PRODUCT/PROCESS CHANGE NOTICE (PCN)

PCN #: TB1601-01 DATE: 16-Feb-2016 Product Affected: P9145 devices (refer to attachment 2 for affected part#) Date Effective: 16-May-2016	MEANS OF DISTINGUISHING CHANGED DEVICES: <input type="checkbox"/> Product Mark <input type="checkbox"/> Back Mark Traceability to the test location is <input type="checkbox"/> Date Code maintained by IDT and available on <input checked="" type="checkbox"/> Other request
---	--

ATTACHMENT 1 - PCN # : TB1601-01

PCN Type: Manufacturing Site - Alternate Test & Backend Location
Data Sheet Change: None
Detail Of Change:

STOCK NO. P8-452-000
 DRAWING NO. MSC-7378
 REV 01

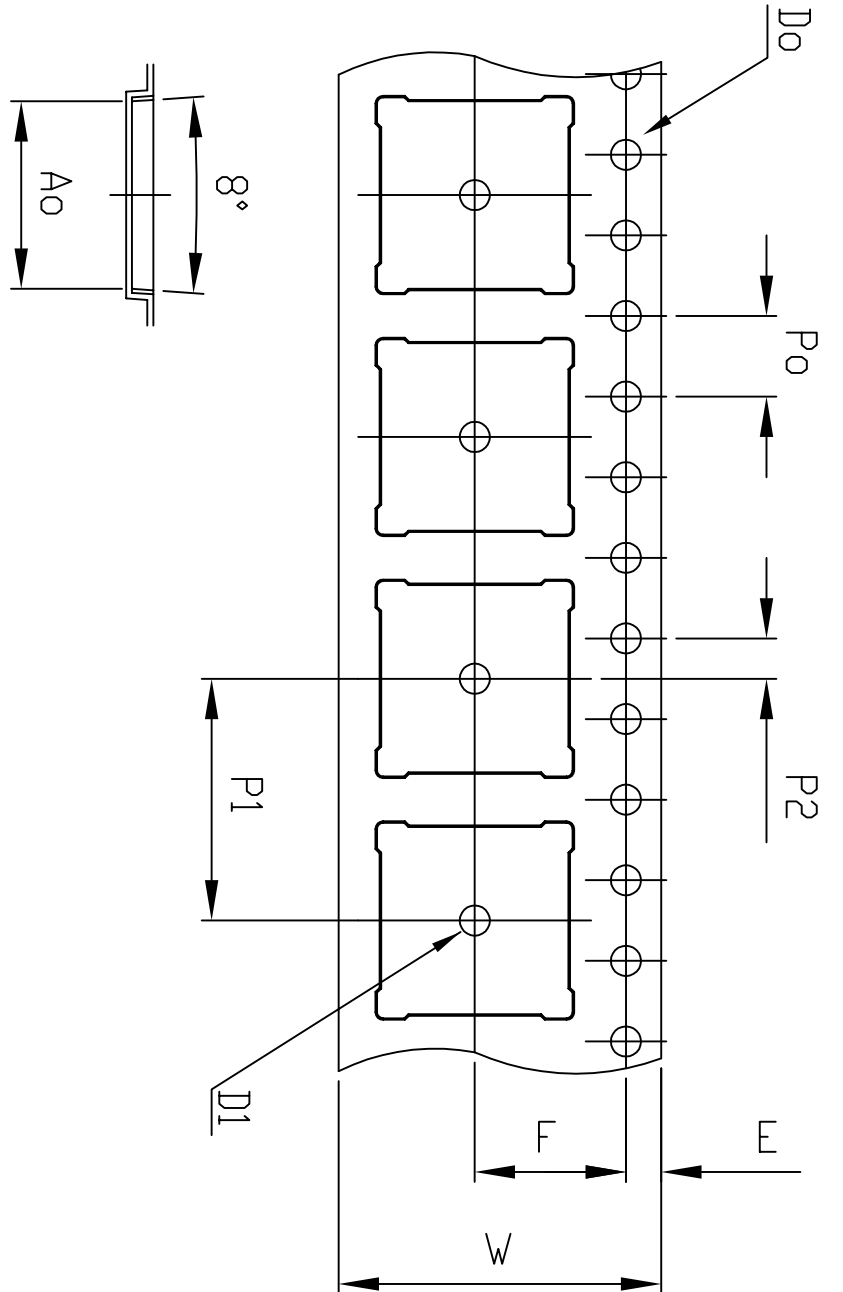
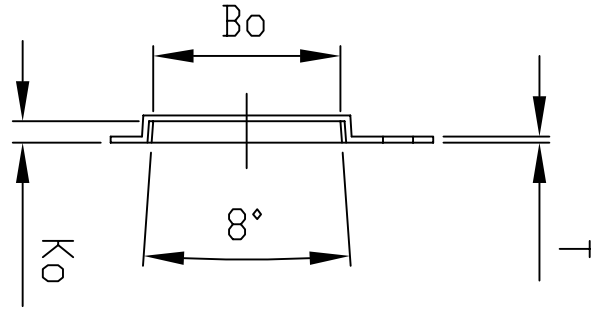
Item	Vendor	Carrier Dimensions		Cavity Dimensions (mm) ±0.1 or Specific				Top View	Drawing
		W (mm.) ±0.3	P1 (mm.) ±0.1	A0	B0	K0	K1		
IDT	PCT QFN9x9GP-20B3-360C-SD	16	12	9.3	9.3	1.05	NA		Refer Attachment 3
Sigurd	ADVANTEK ML0909-D	16	12	9.3	9.3	1.05	NA		Refer Attachment 4

Attachment 5 - Plastic Reel

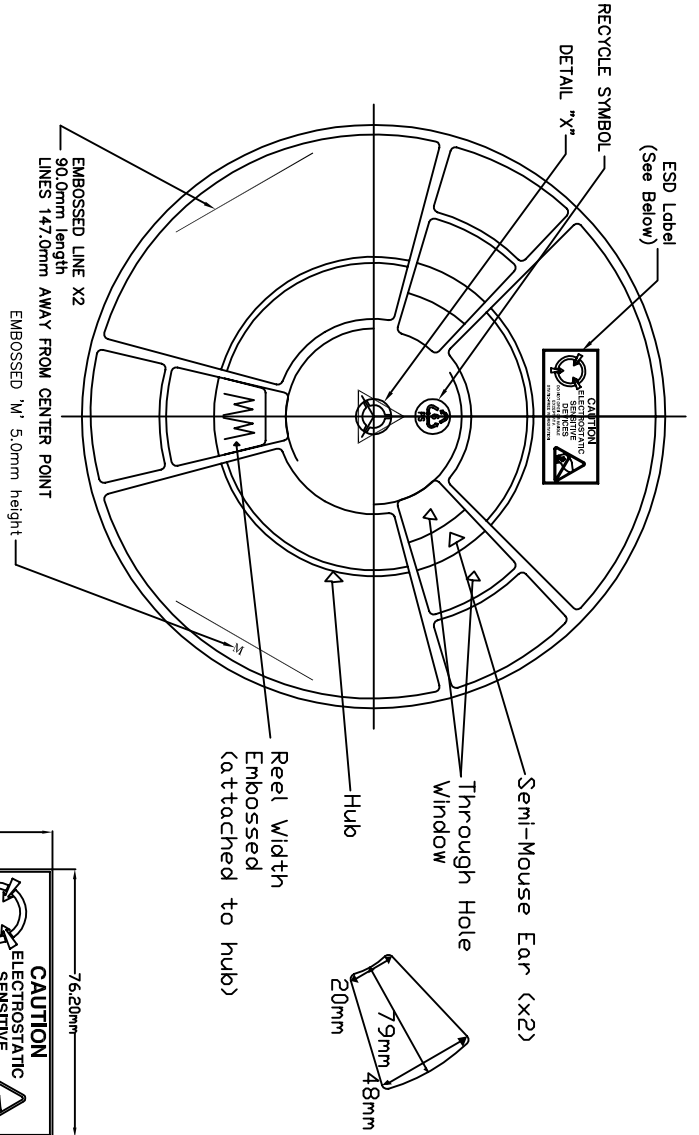
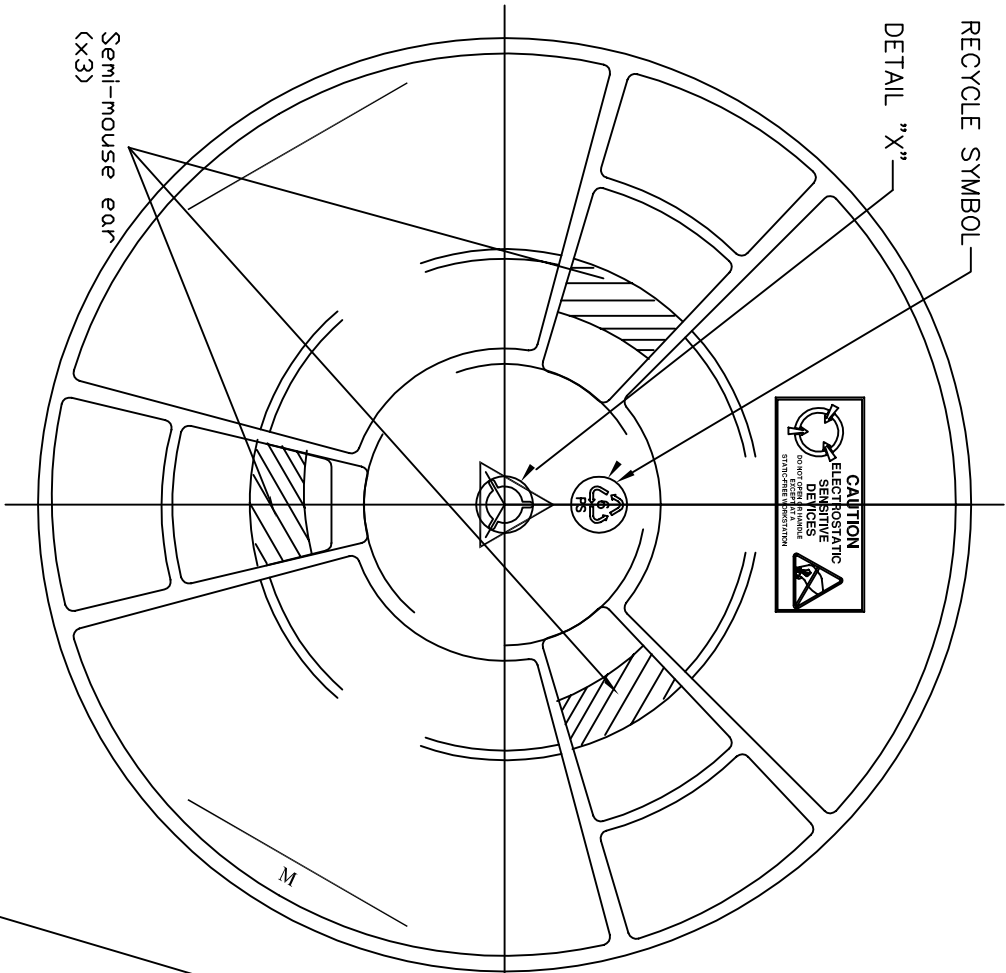
Item	Vendor	(A) Reel Dia. (inch)	(N) Hub Dia. (inch)	Color	Snapshot	Drawing
IDT	TAIPEX 3.3C161307(BLK)	13"	7"	Black		Refer Attachment 5
Sigurd	TAIPEX 3.3C161307(BLK)	13"	7"	Black
